Groundwater Transfer Review Summary Form

Transfer/PA # T- 14673

Application: T-17673

Applicant Name: Eagle Crest Master Association

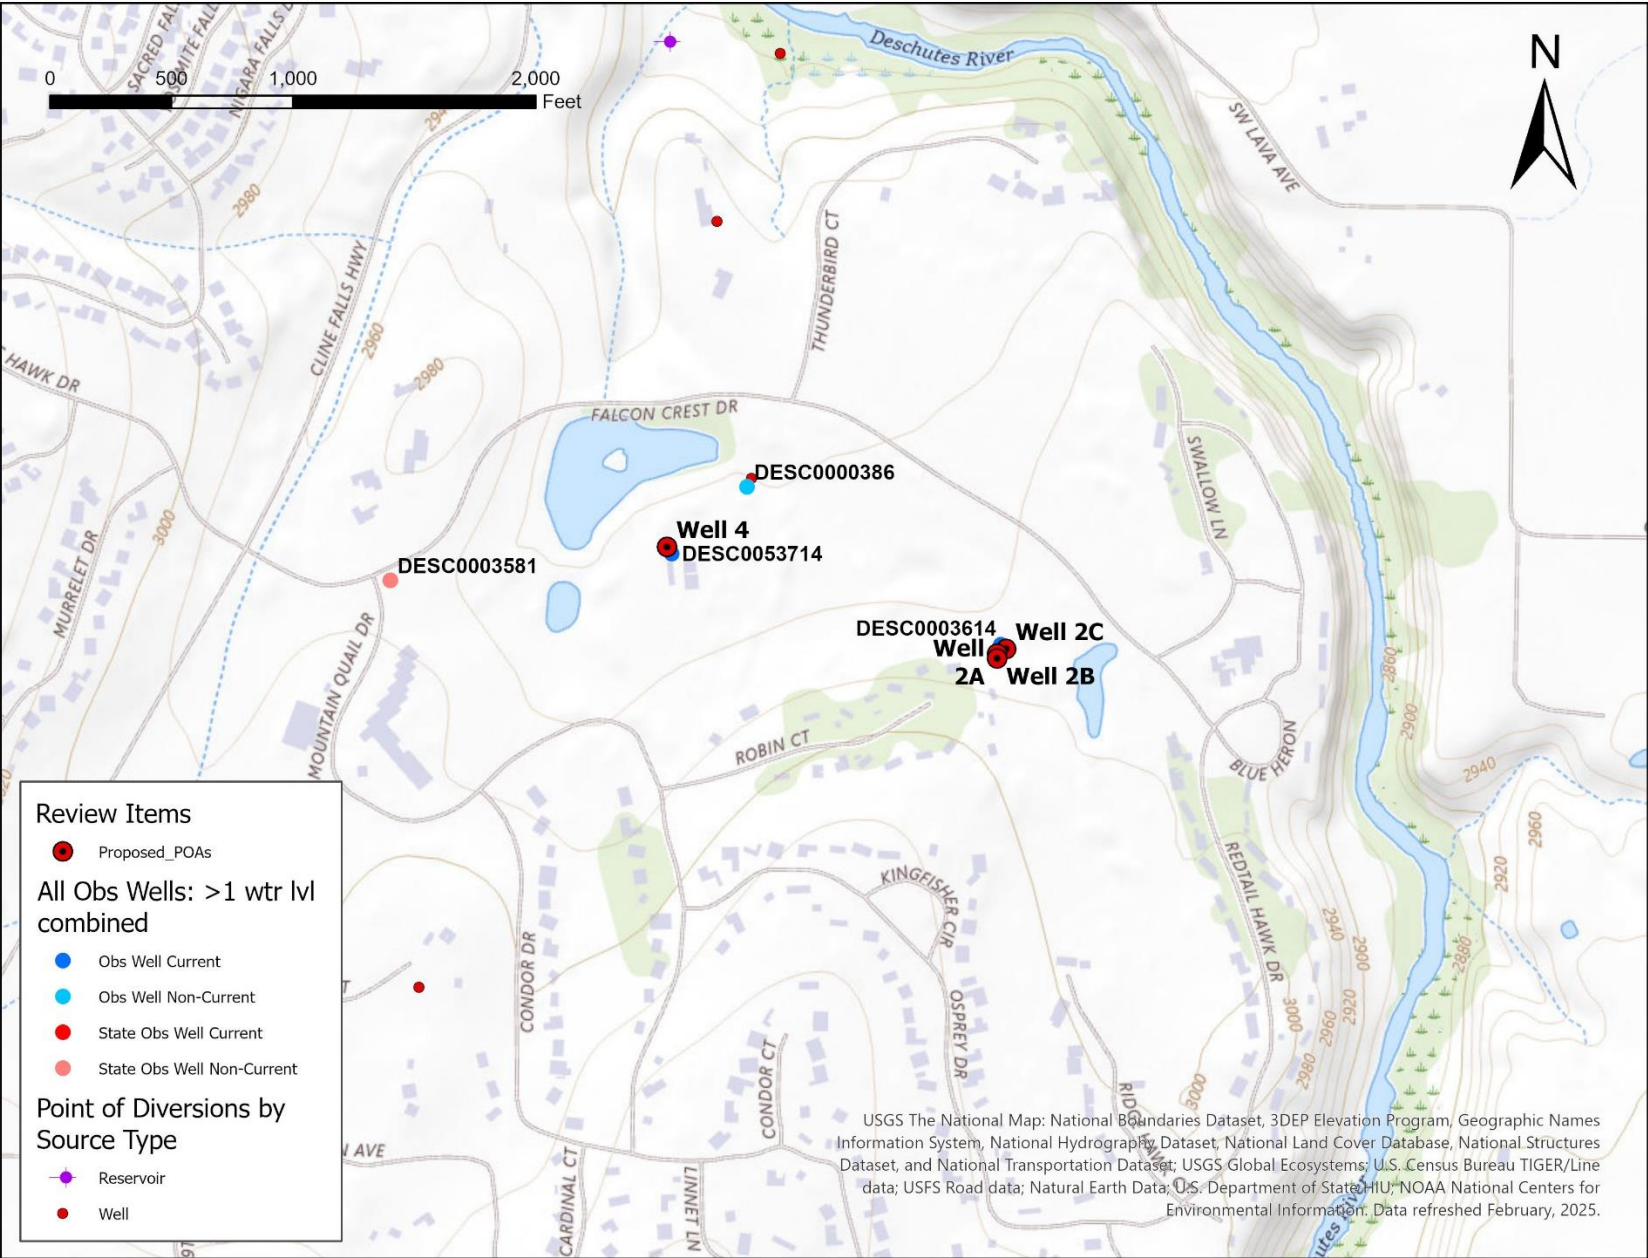
b) If yes, for each POA identify the reference level, most recent spring-high water level, and whether an applicable permit decline condition has been exceeded: Supporting documentation states that the reference level for preceding permits for Certificates 95068/95069 should be either March of 1995 or 1996. Water levels at DESC 3581 are higher in March 1995 than March 1996. DESC 3614 was constructed in 1979, but other POAs on these water rights had not yet been drilled at the time. This portion of the Deschutes aquifer has very low gradient and water levels in wells track very closely with one another. The hydrogeologic setting and multiple observation wells in the area allow one to model what the March 1995 water level for each of the valid or proposed POAs.

March 1995 water levels for DESC 57946 and DESC 59818 are calculated by subtracting 18 feet from their 2017 water levels (based on observed changes in DESC 3581). DESC 3614, DESC 53714, DESC 57946, and DESC 59818 all declined approximately 11.7 feet from 2017 to 2024. March 1995 water level for DESC 64749 are calculated by subtracting 11.7 and 18 feet from the March 2024 measurement.

Transfer Map

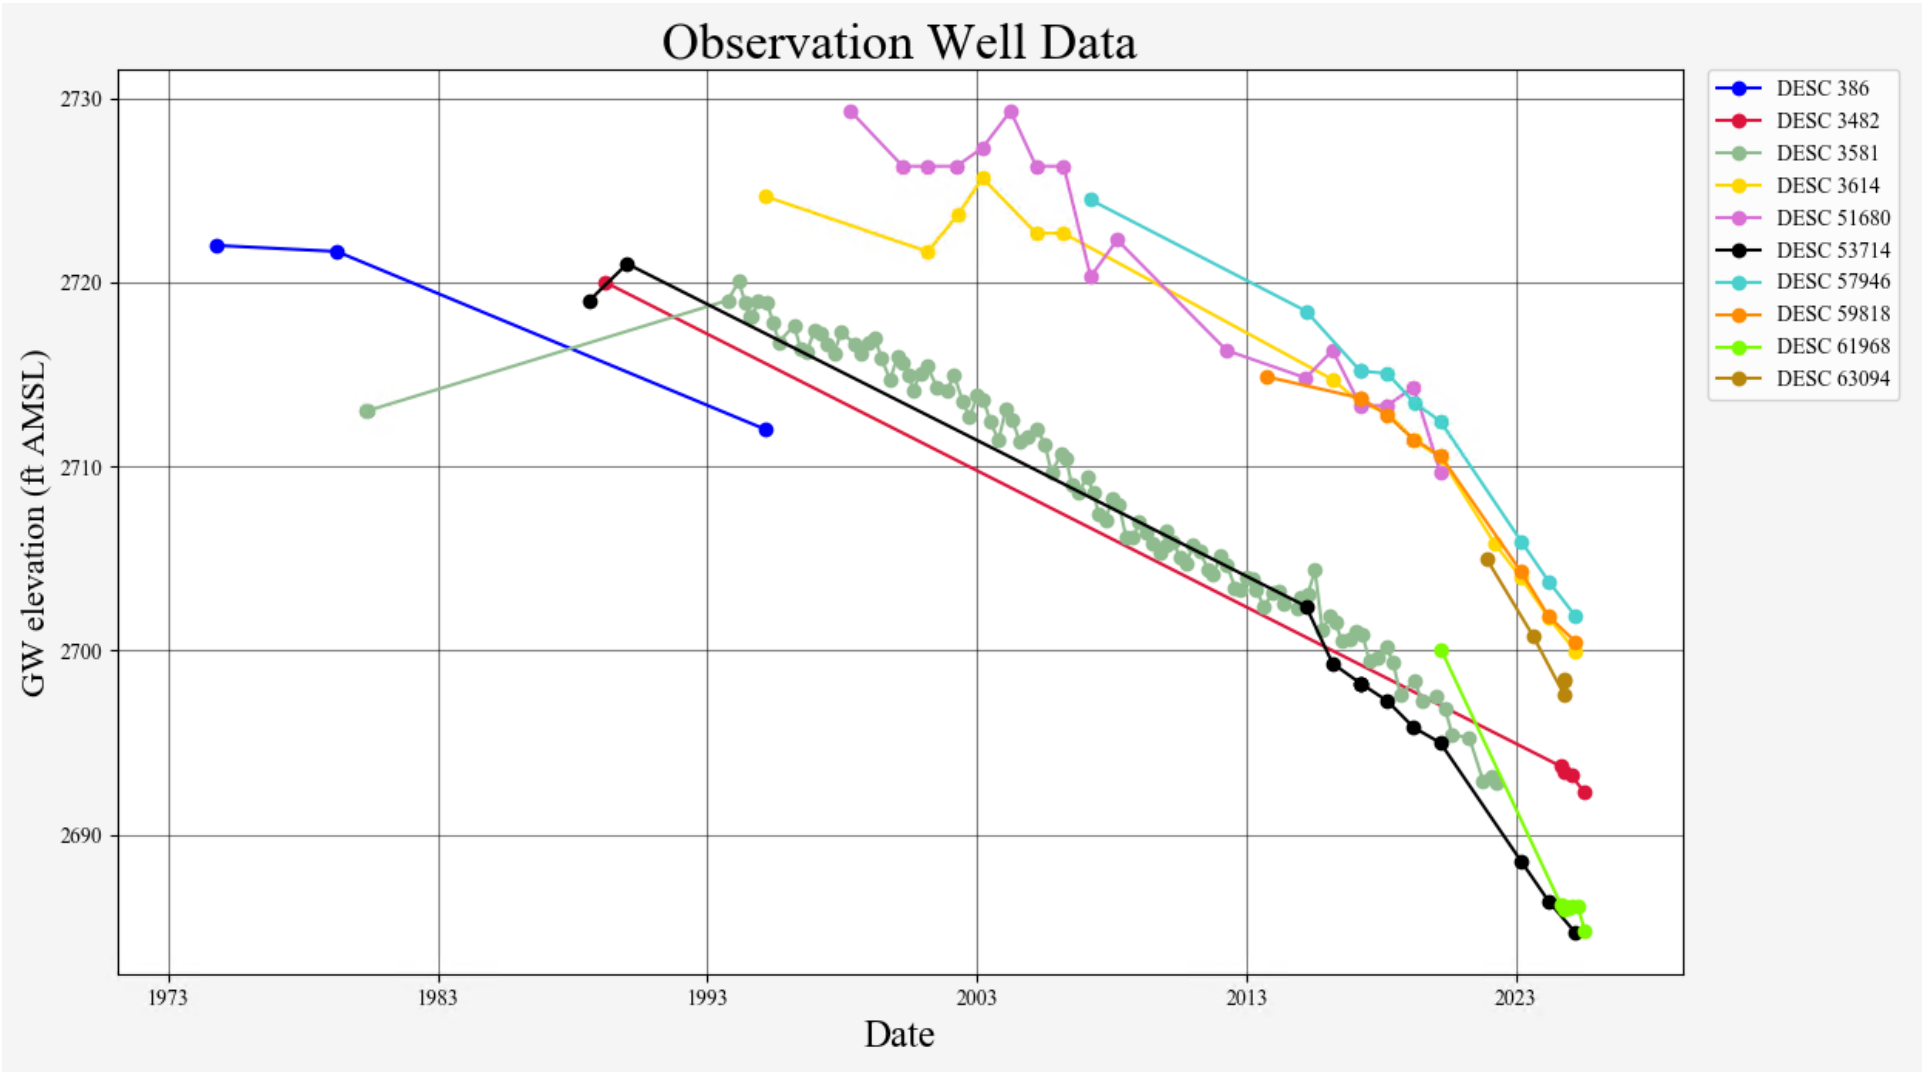
5. a) Will this proposed change, at its maximum allowed rate of use, likely result in an increase in interference with **another ground water right**?
☒ Yes ☐ No Comments: Changing from DESC 3614 to DESC 64749 will move groundwater pumping approximately 30 feet closer to wells on the east side of the Deschutes River (approximately 3000 feet from the applicant's wells). This shift will cause a slight increase in well-to-well interference with those wells.

6. a) Will this proposed change, at its maximum allowed rate of use, likely result in an increase in interference with **another surface water source**?
☐ Yes ☒ No Comments: The closest GW-SW interaction occurs at the Lower Bridge area which is 8 miles to the north. The APOA is approximately 15 feet closer to that point. The new well location will create a negligible change in stream depletion with the Deschutes and Crooked Rivers.
